THE GARDENS OF COTTAGE HILL SUBDIVISION, PHASE FIVE

APPLICATION	NUMBER 15 DATE April 6, 2005	N
APPLICANT _	The Gardens of Cottage Hill Subdivision, Phase Five	ļ
REQUEST	Subdivision	
~	T .	STV

DETAIL SITE PLAN

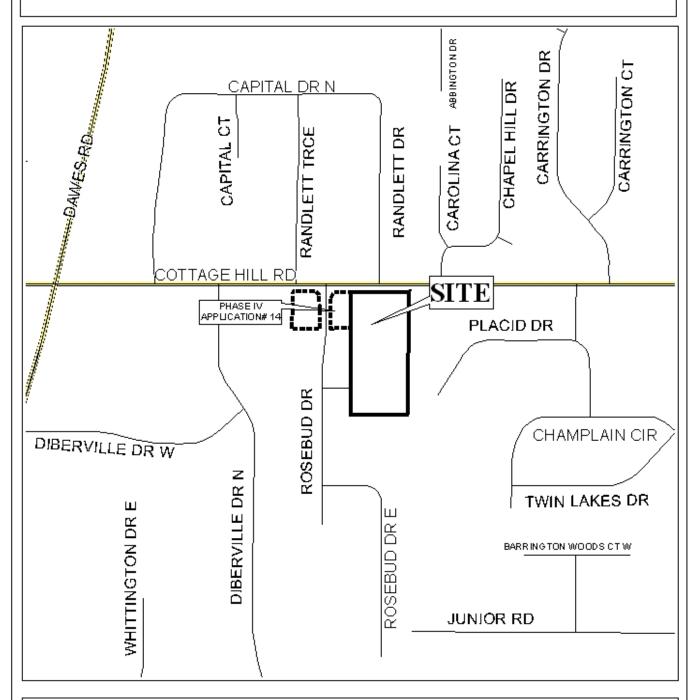
The site fronts Rosebud Drive, with a 50-foot right-of-way; and Cottage Hill Road, a planned major street requiring a 100-foot right-of-way, which has an existing 80-foot right-of-way. As would be required, the plat illustrates dedication of an additional ten feet of right-of-way along Cottage Hill Road. The final plat should also illustrate dedication of 25-foot curb radii at the corners of Rosebud Drive and Cottage Hill Road. The subdivision involves the creation of new streets, which must be constructed and dedicated to County Engineering standards.

The applicant is proposing an "innovative subdivision" of single-family patio homes with a green space area providing compensating open space for the smaller sized lots. Including the green space, the site meets the maximum density requirements. A note should be required on the final plat stating that common area maintenance will be property owners' responsibility. The common area also should not be allowed any curb cuts to Cottage Hill Road.

The absence of detention areas may pose some concerns, especially since, being located in the County, the site is not subject to maximum site coverage restrictions. While there is a large detention area immediately South of the site, this was approved for a plat showing the subject area (and the area of Phase Four now being considered) as three very large lots. The present applicant proposes significant changes in build-out, which would significantly increase impervious coverage and likely impact the detention. Thus, the applicant should provide evidence that the existing detention could accommodate the proposed build-out, or should provide additional detention, both subject to County Engineering approval.

Based on the preceding, this application is recommended for Tentative Approval, subject to the following conditions: 1) dedication of sufficient right-of-way to provide 50 feet from the centerline of Cottage Hill Road, as shown on the plat; 2) dedication of 25-foot curb radii at the

corners of Rosebud Drive and Cottage Hill Road; 3) construction and dedication of the new street to County Engineering standards; 4) the provision of additional detention, if deemed necessary by County Engineering; 5) the placement of a note on the final plat stating that any lots that are developed commercially and adjoin residentially developed property must provide a buffer, in compliance with Section V.A.7 of the Subdivision Regulations; 6) the placement of a note on the final plat stating that the site is denied access to Cottage Hill Road; and 7) the placement of a note on the final plat stating that maintenance of common areas will be property owners' responsibility.
